# STAFF RECOMMENDATION

J. Hirsch  
NCPC File No. 7246

## UNITED STATES DIPLOMACY CENTER Harry S Truman Building

May 26, 2011

USDC Entry Pavilion circulation. Visitors will enter through the north and staff will enter through south screening station.

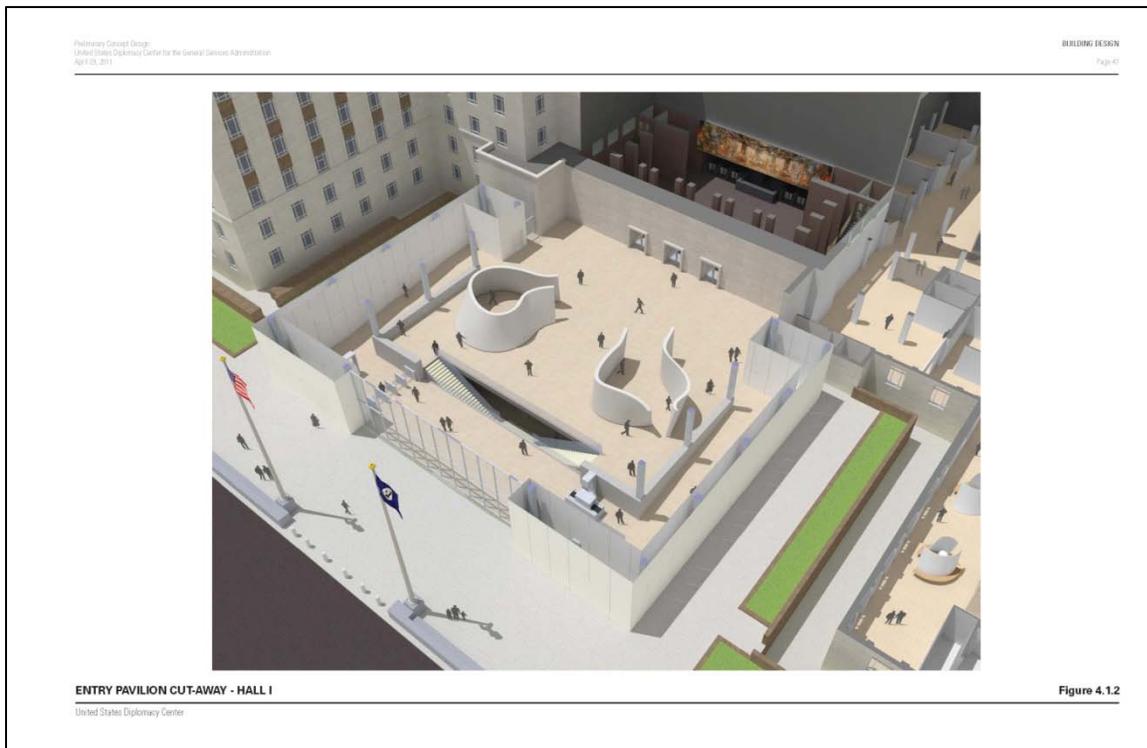
The DOS has indicated that the 21<sup>st</sup> Street entrance has two peak entrance times during the day with one in the morning between 7:00 am and 9:00 am, and one in the evening between 5:00 pm and 7:00 pm. The proposed circulation scheme shows all pedestrian traffic exiting the building through the south screening station.
